RE: **APPROVAL** of **1000 gallon** Ace Roto-Mold Two Compartment Polyethylene Septic Tank for use in Wyoming.

CLIENT / DESCRIPTION: 1000 GAL. TWO COMPARTMENT SEPTIC TANK

PART NO. AST–1000–2

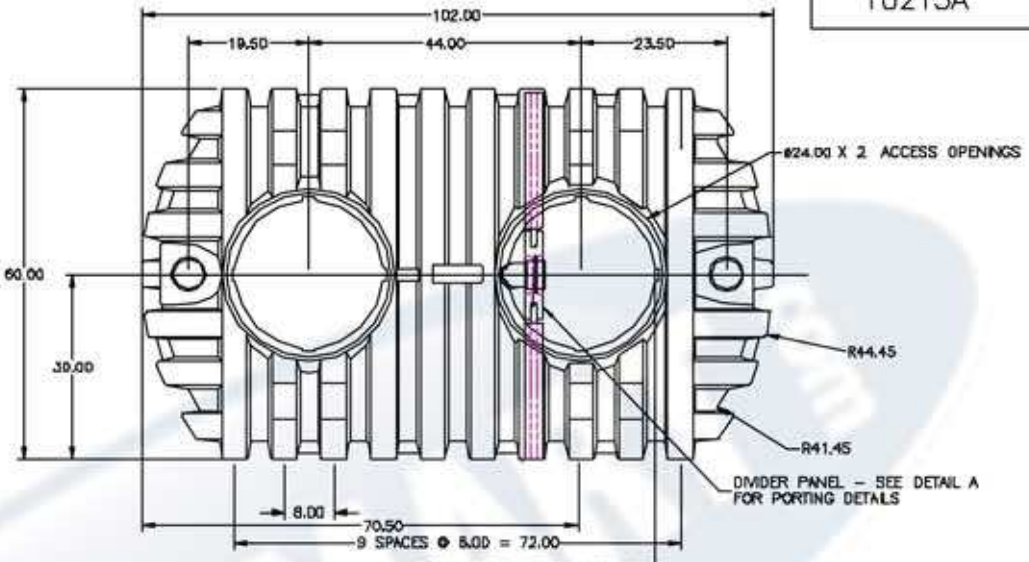
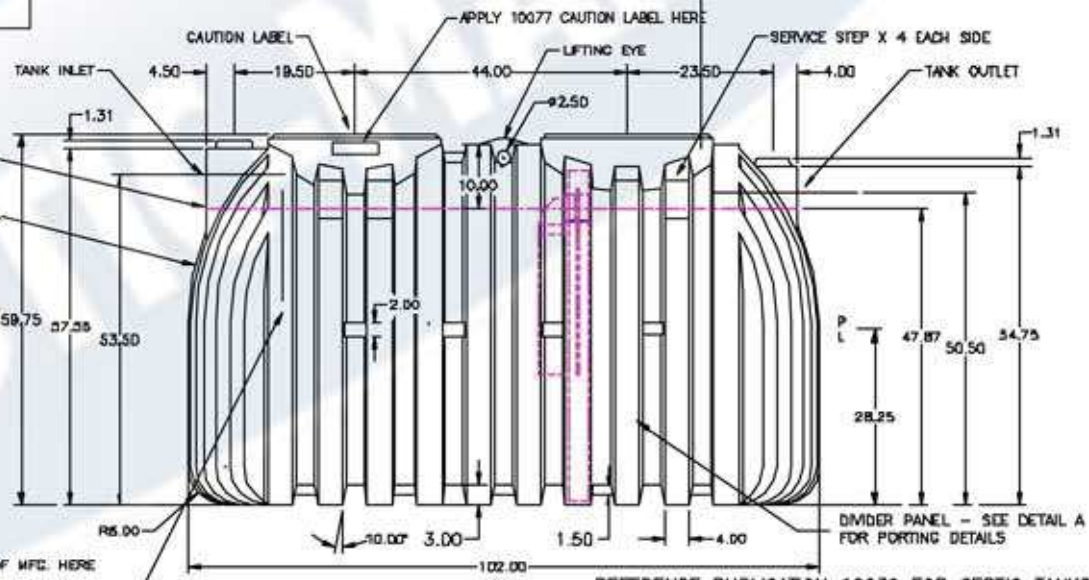
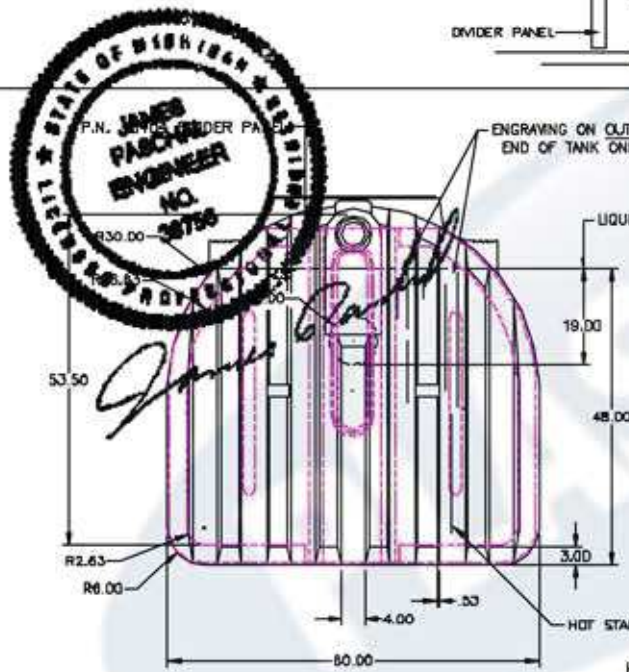
1. The manways on the septic tanks (one on each compartment) must be extended to the ground surface because there are no clean-outs provided on the Ace Roto-Mold polyethylene septic tanks.

2. The downward extending legs on the inlet and outlet baffling tees must extend into the middle third of the septic tank liquid.

3. To ensure structural integrity, the manufacturer's instructions regarding filling the tank with water during burial and immediately after pumping it out must be followed during installation and clean-outs.
